BULLETIN NO. 2

Rocky Hill Intermediate School – Phase 2, Rocky Hill, CT

Rocky Hill Intermediate School Pre-Bid RFI Log – Bulletin 002
Updated: March 21, 2018

24 SOFFIT DETAIL
1" = 1'-0"

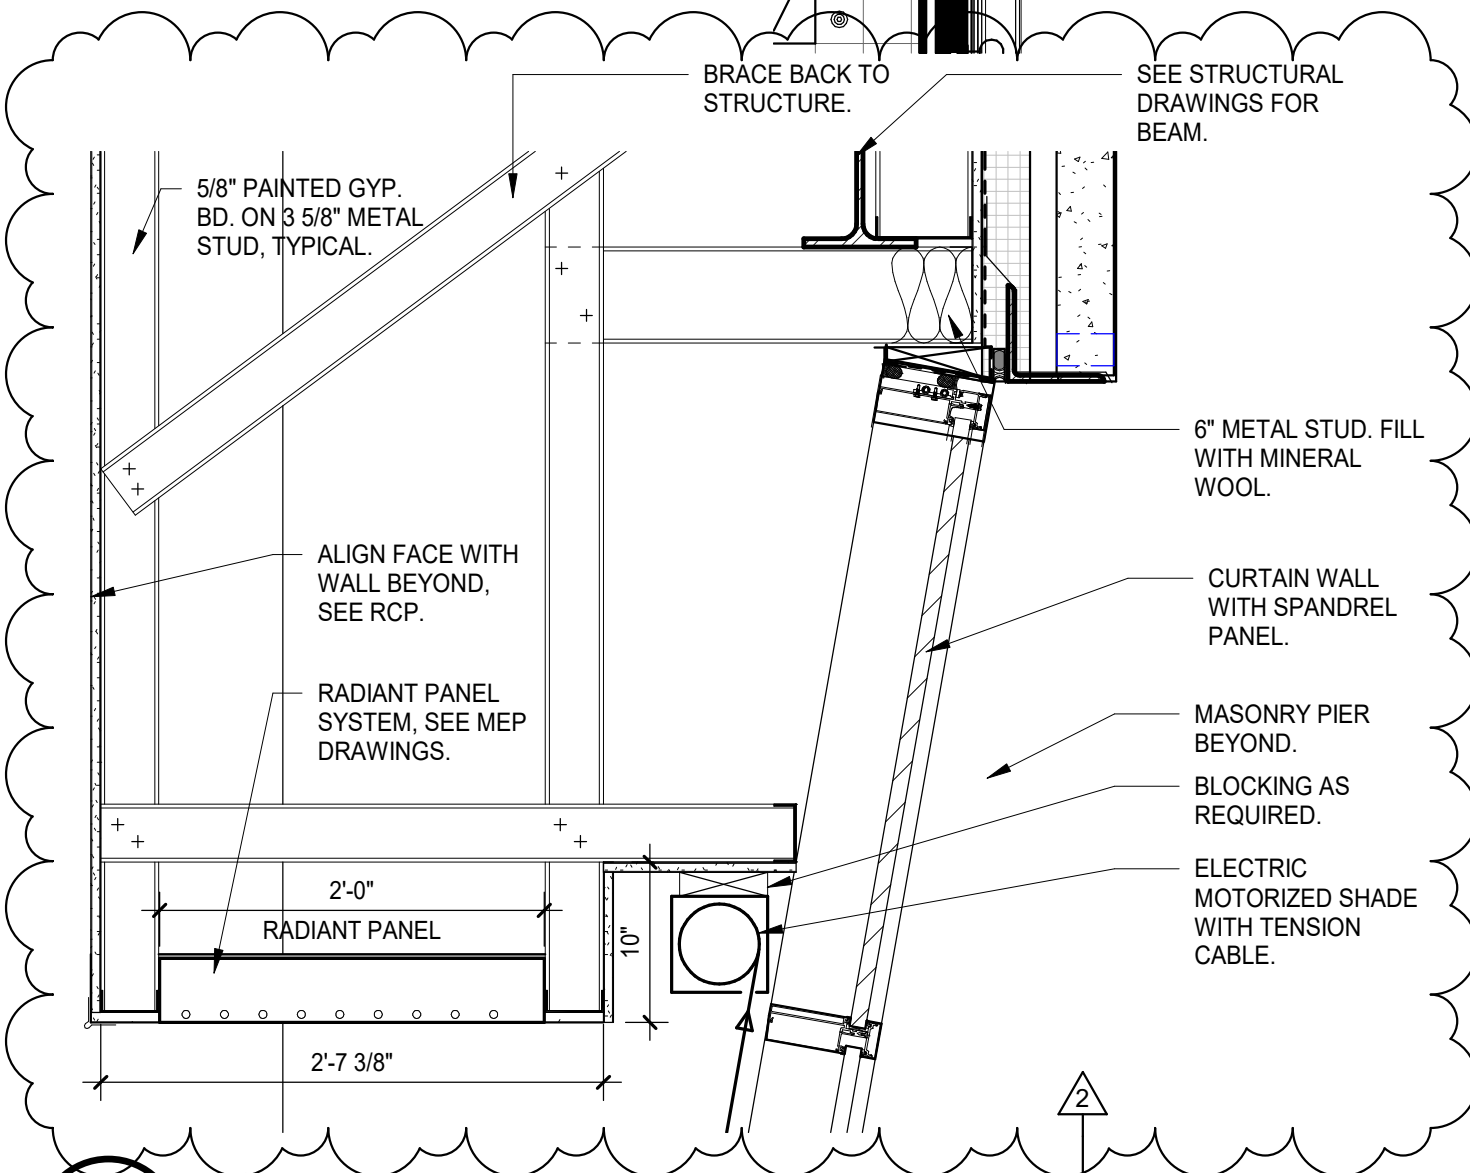
Revise detail 24, see SKA2.08

REFERENCE
DETAIL/SHEET: S05/A8.02

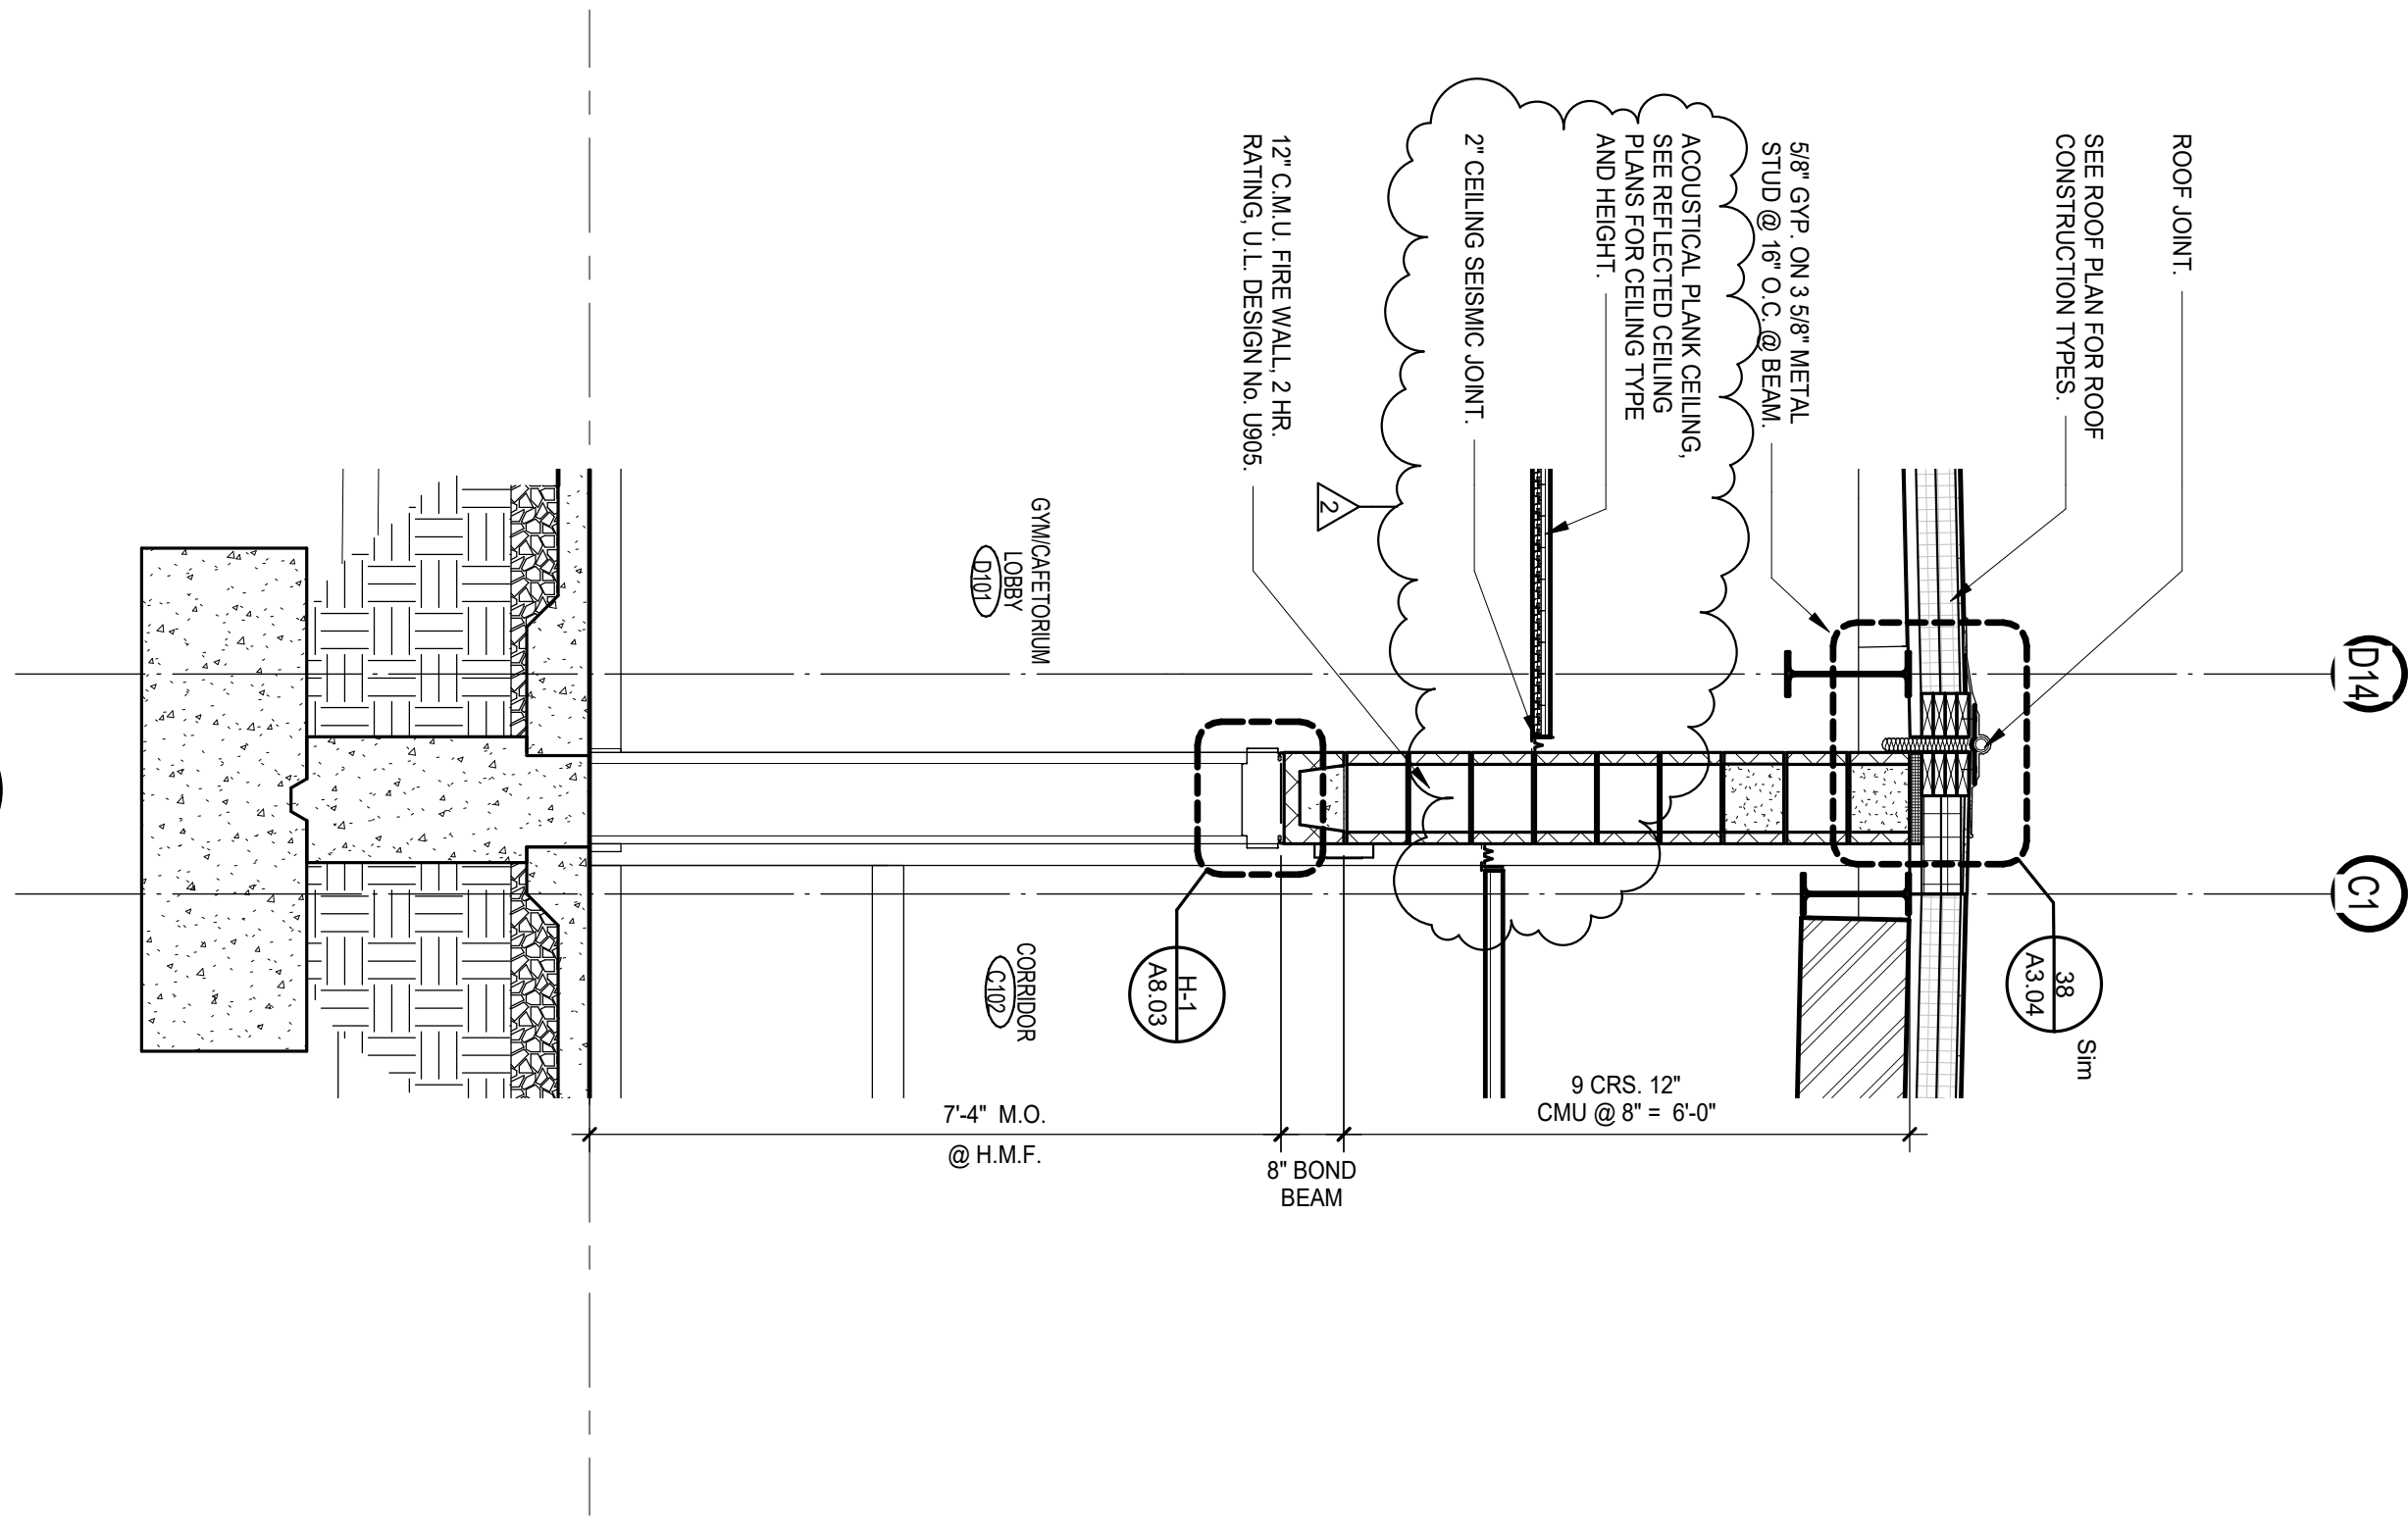
A8.02 DOOR, FRAME, AND OPENINGS ELEVATIONS
Revise height of frame S05, see SKA2.09

SECTION CR1 REVISED

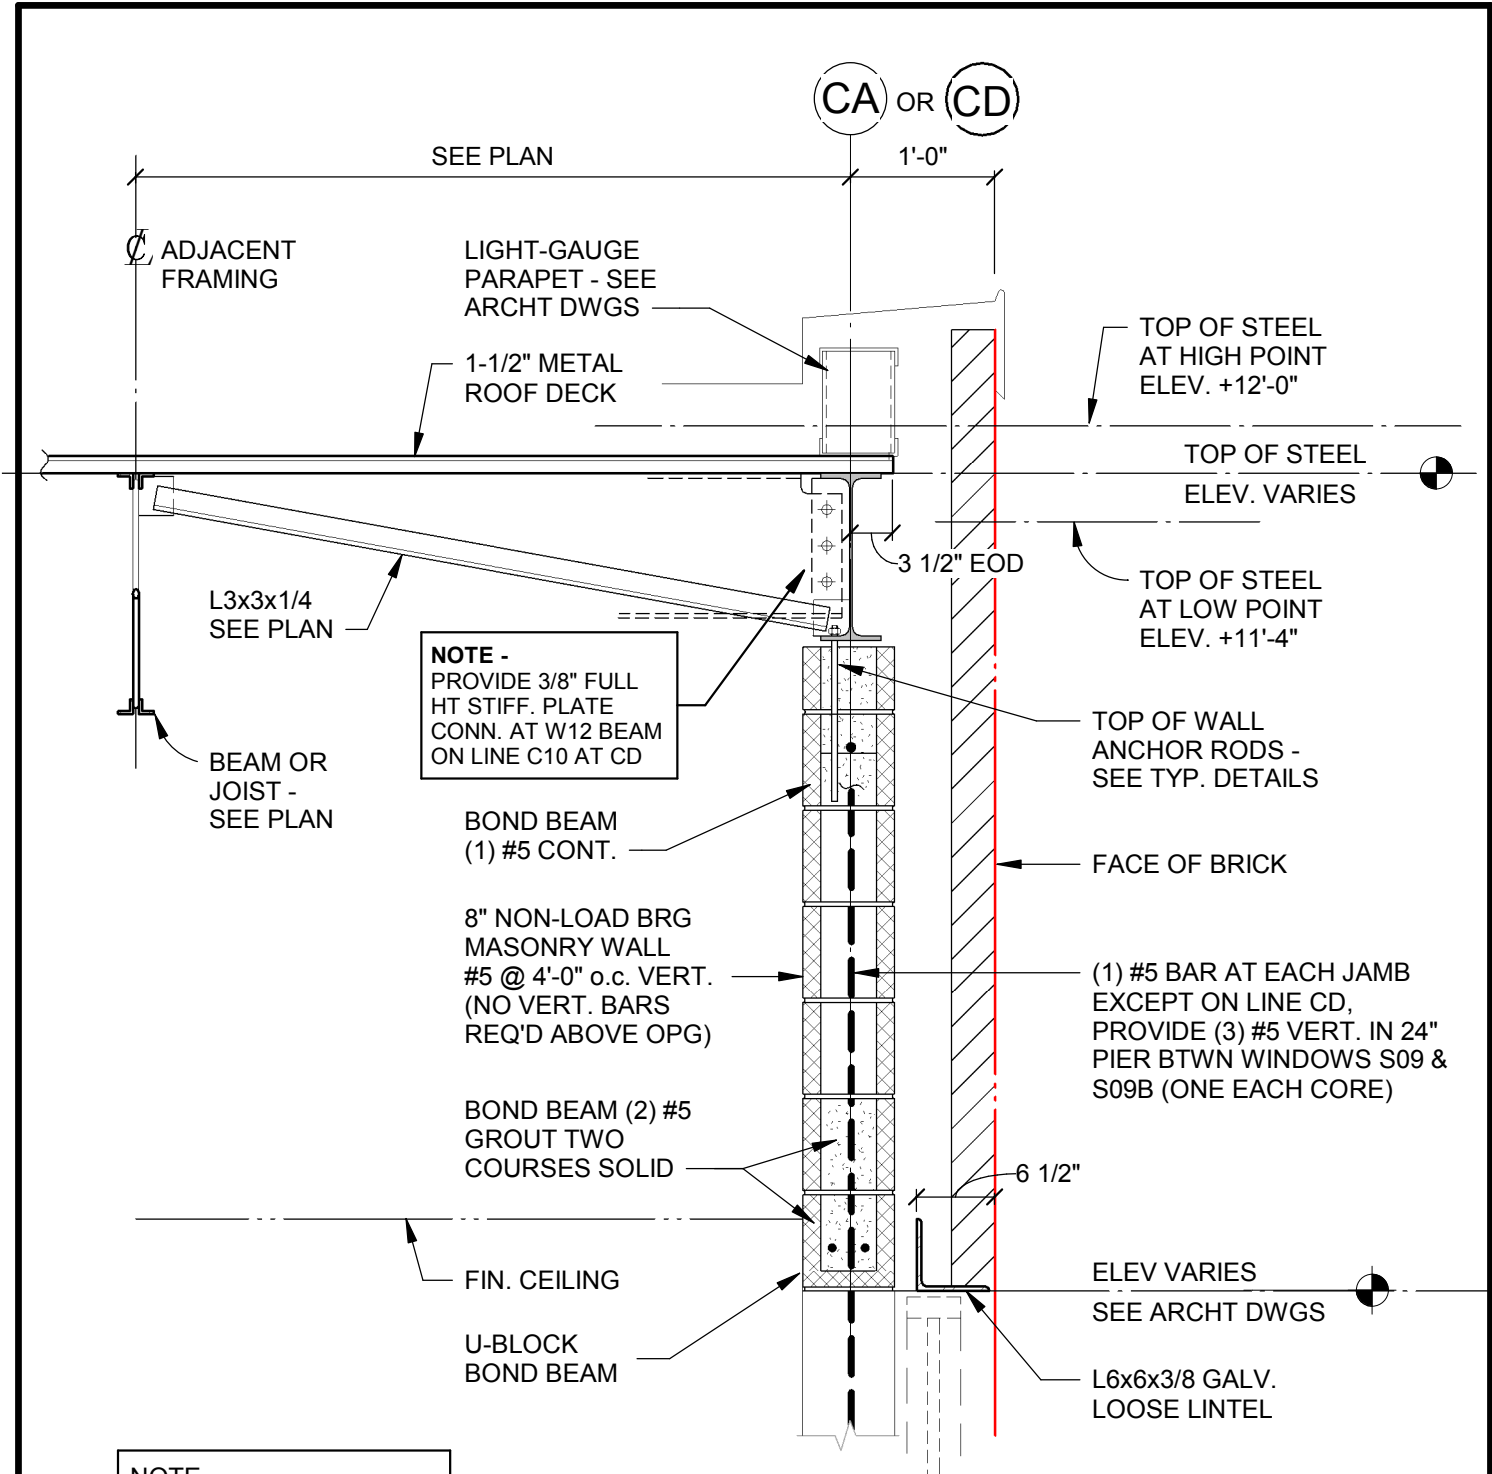
See SKS-2.02 for revised SECTION CR1.

NOTE -
 PROVIDE 3/8" FULL
 HT STIFF. PLATE
 CONN. AT W12 BEAM
 ON LINE C10 AT CD

NOTE -
 REVISED SECTION CR1
 ALSO APPLIES ONLINE
 CD BETWEEN C7 & C12
 (NOT CUT ON PLAN)
